## Notice of Decision & SEPA DNS

### DaVita Dialysis Clinic Site Plan Review & SEPA DNS

Land Use Application Nos.:	SPR-22-012 (Site Plan Review Type II) SEP-22-011 (SEPA)
Applicant:	LDC Inc C/O Ross Jarvis 1411 State Avenue NE Olympia, WA 98506
Property Owner:	Brooks Douglas LLC C/O Mark Luna 3241 Laurel RD Longview, WA 98632
Site Location:	467 Beechwood Street Woodland, WA 98674
Parcel No. & Size:	50451
Zoning Designation:	C-2, Highway Commercial
Date Application Received:	November 17 <sup>th</sup> , 2022
Notice of Complete Application Issued:	November 30 <sup>th</sup> , 2022
Notice of Application & Likely DNS issued:	December 2 <sup>nd</sup> , 2022
Comment Period & SEPA Appeal Period Ended:	December 21 <sup>st</sup> , 2022
Notice of Decision Issued:	December 22 <sup>nd</sup> , 2022
DRC Decision	Approve with Conditions

RIGHT-OF-WAY EASEMENT  
POWER UNDERGROUND

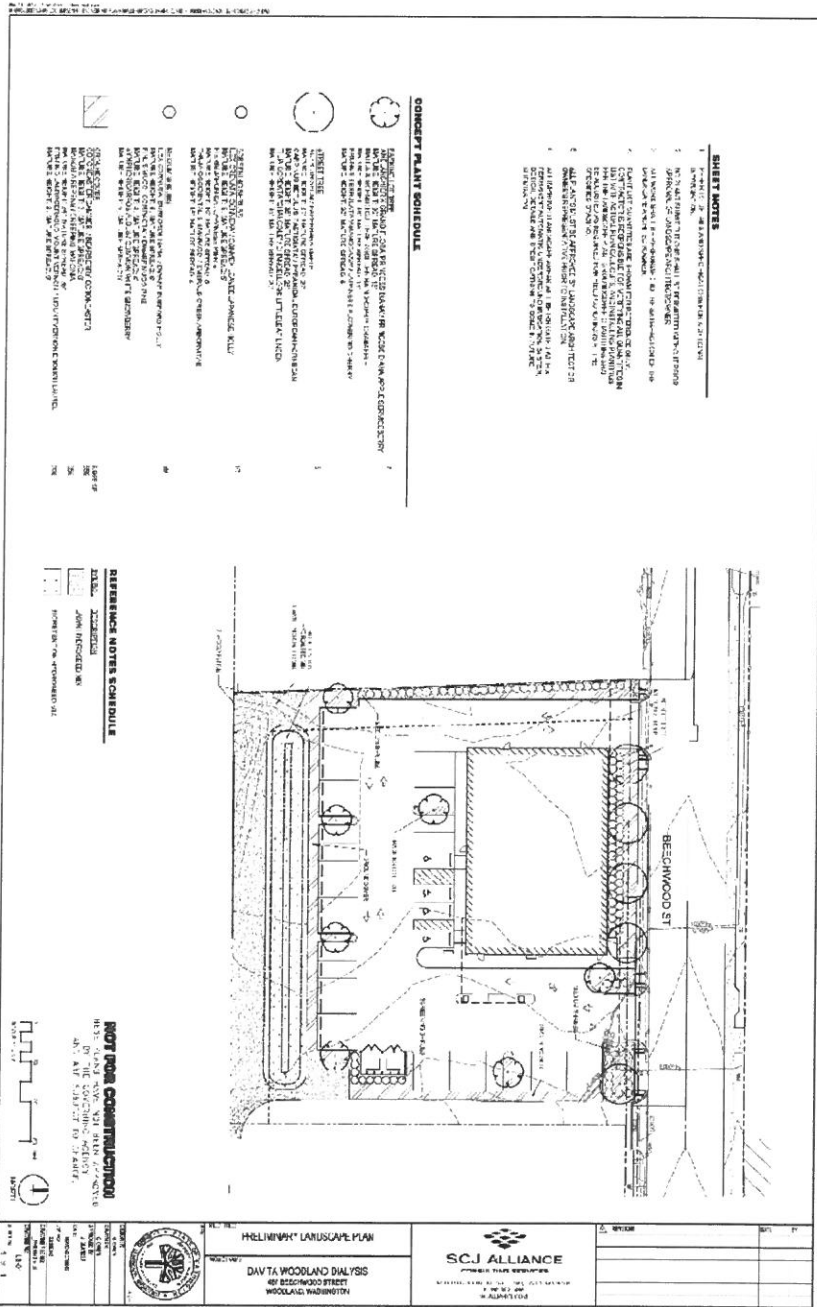
**Finding 20:** There is a 10 ft utility easement that runs adjacent to the property line along the Beechwood Street frontage. *See Attachment A – Site Plan and Attachment B – Underground Electrical Easement filed under AFN 3619523.*
